Our File: 2610

Re: Peer Review - Hydrogeology - Gravel Pit (Zoning Amendment - RZ002-2026)

Harden Environmental Services Ltd. (Harden) is pleased to provide hydrogeological comments for zoning by-law amendment application for the Lichty Pit. The address is 5999, 6043, 8th Line East & 7190 Side Road 12, Part of Lots 11 & 12, Concession 4 West, Township Of Centre Wellington, Township of Pilkington, County of Wellington

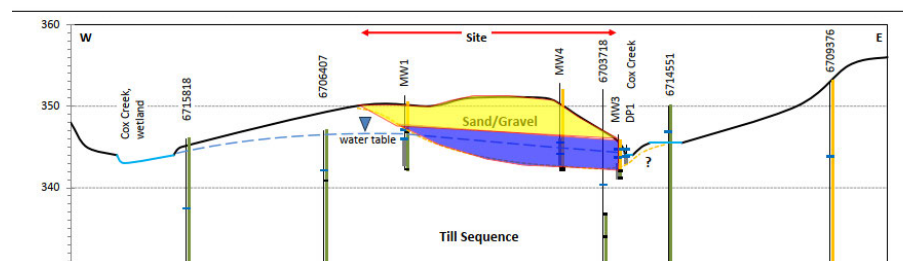
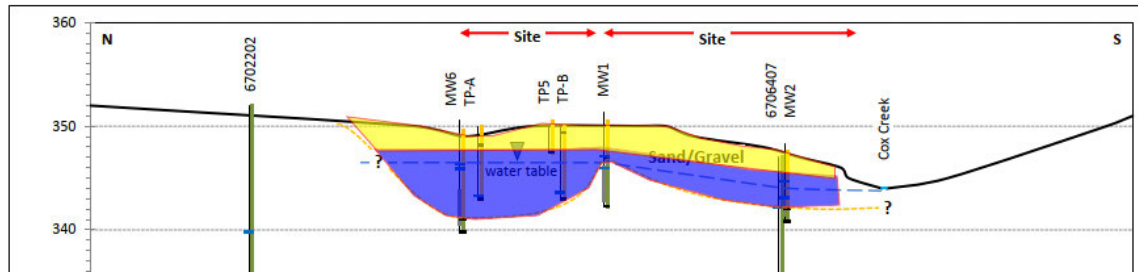
We have attached the two cross-sections prepared for this site and find that the proposed above water table extraction will not allow for the removal of approximately 50% of the aggregate at this site. The yellow highlighted areas approximate the above water table resources, and the blue highlighted areas are an approximation of the below water table resources.
